REQUEST FOR INFORMATION DATE: June 02, 2016 NO.: RFI-147

Project Name: 15051-Webster University Interdisciplinary Science Building Project No.: 15051

Subject: AVB at detail 3/A421

A0421

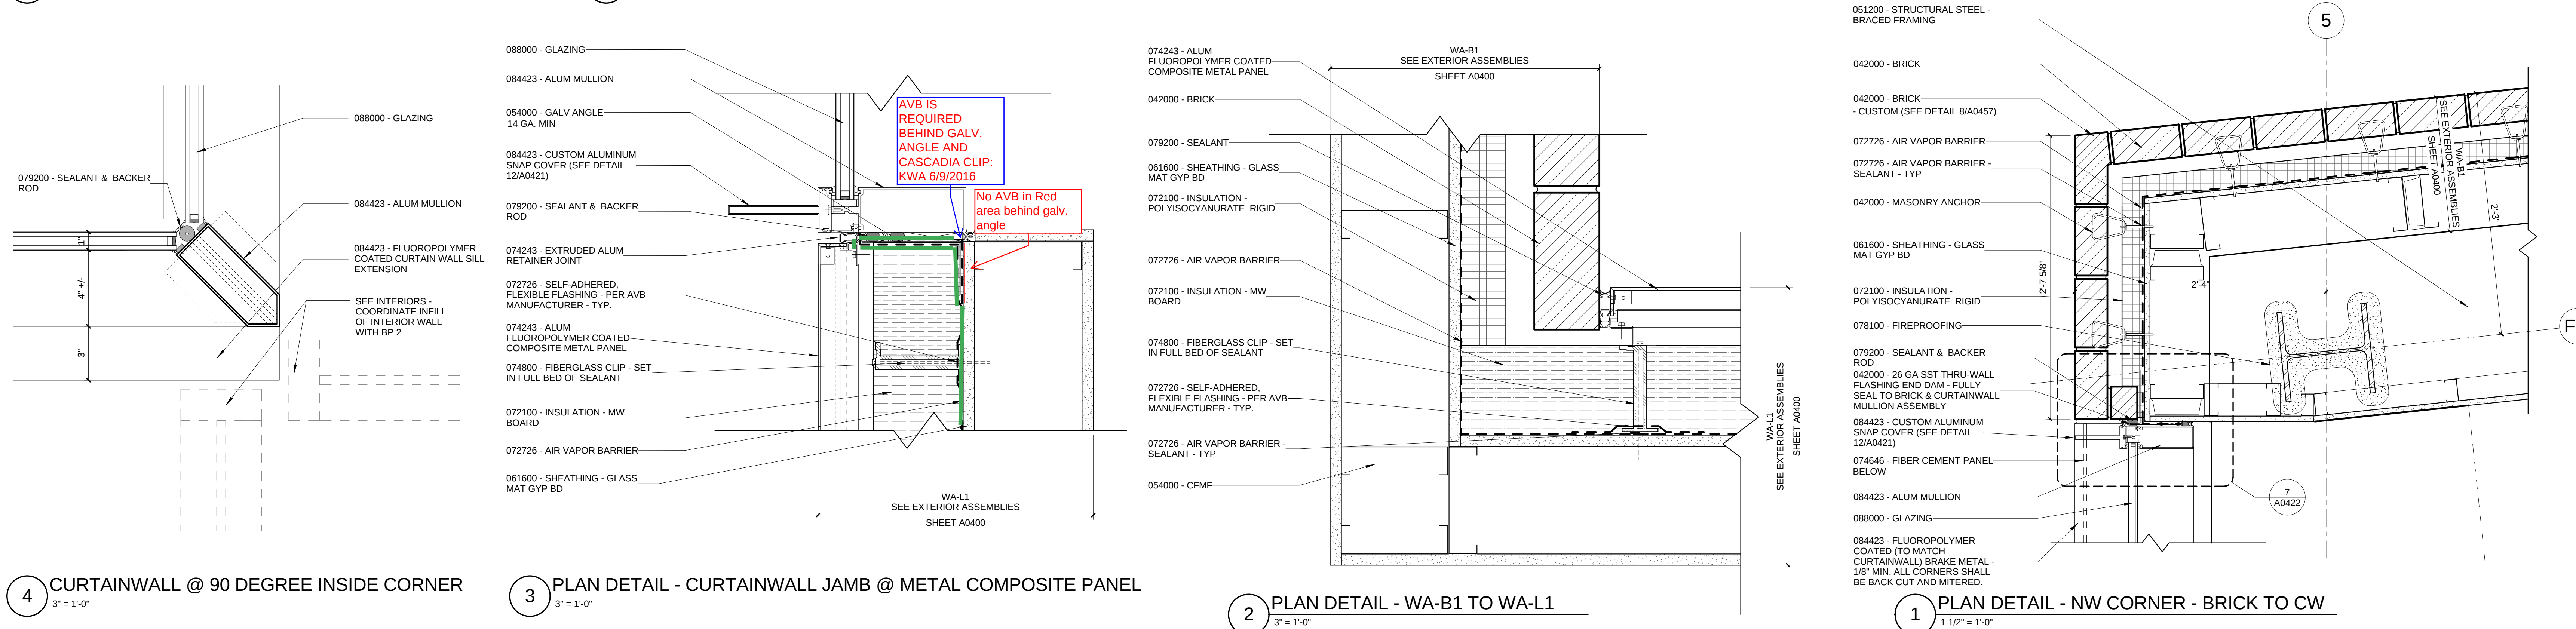
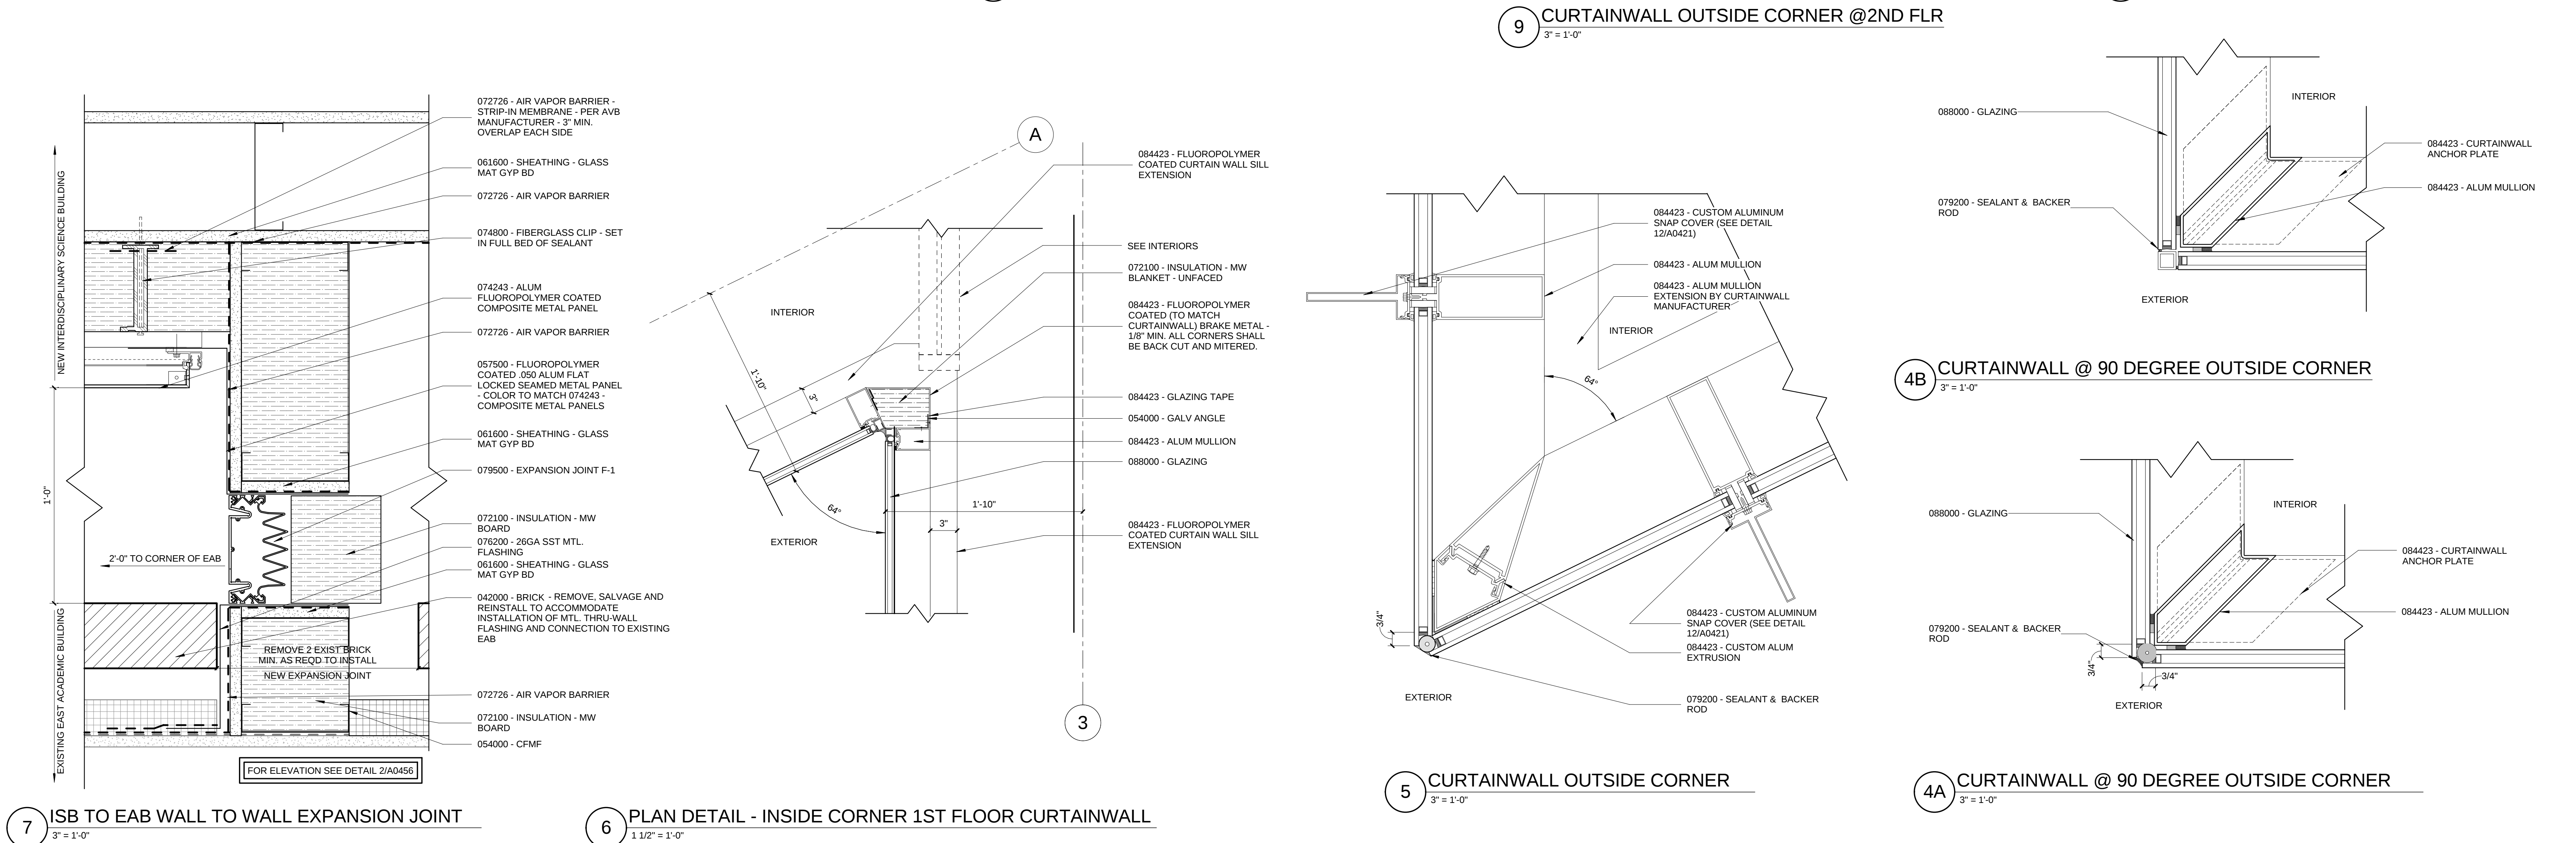
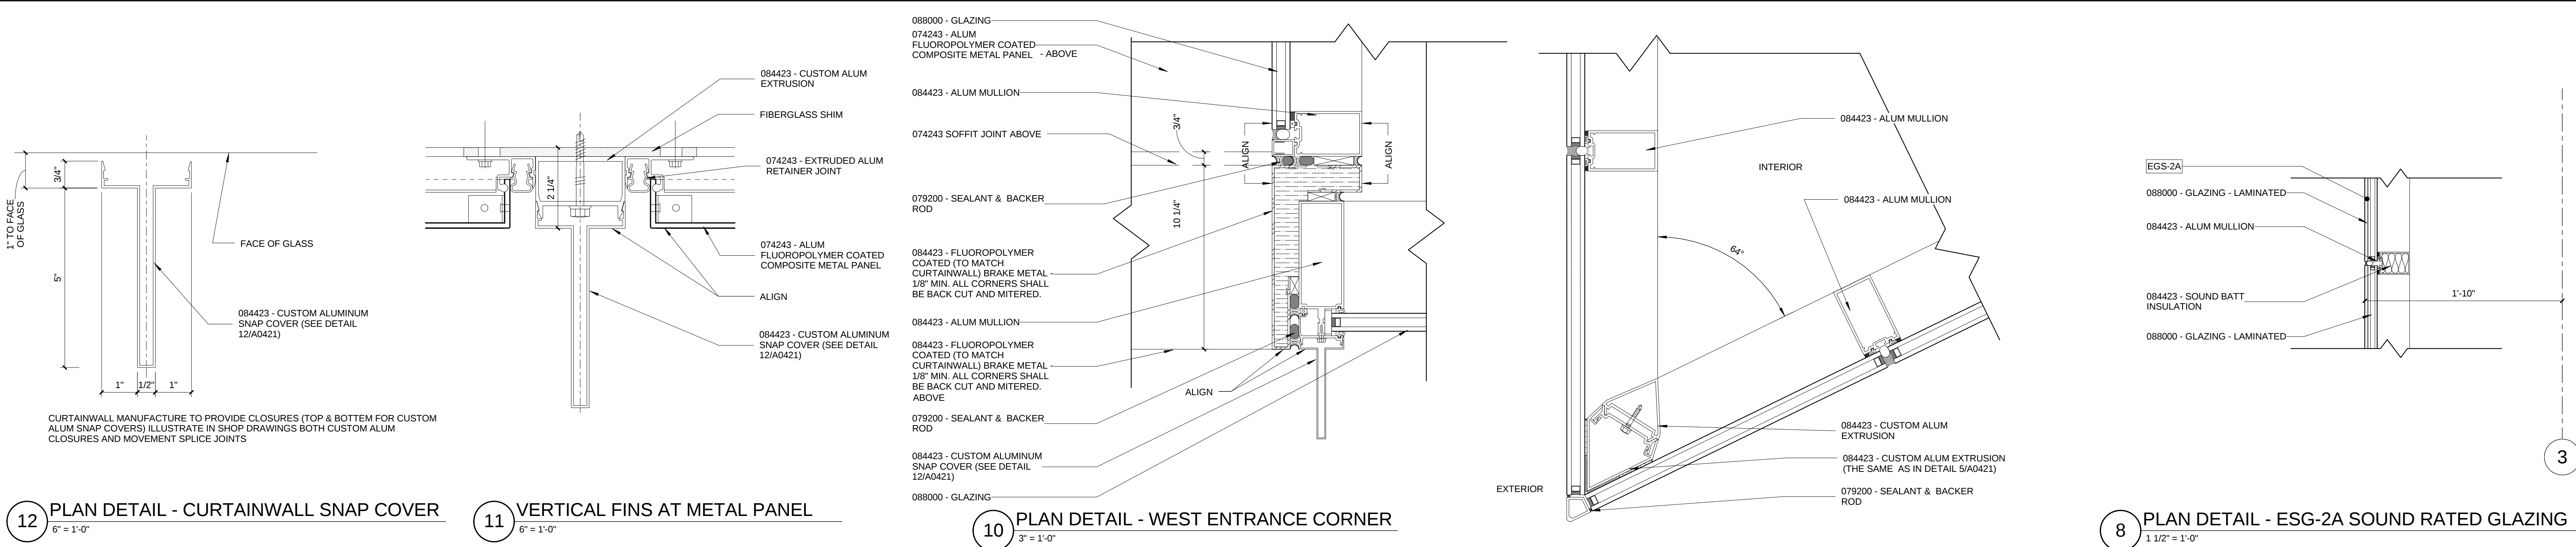
Please confirm the AVB is not required behind the Galvanized angle (area indicated in red on attached plan). The angle will be placed in contact with the sheathing and the AVB will be placed over it and returned into the jamb (area denoted in green).

Please see KWA's response on the
attached drawing: Sheet A0421
6/9/2016
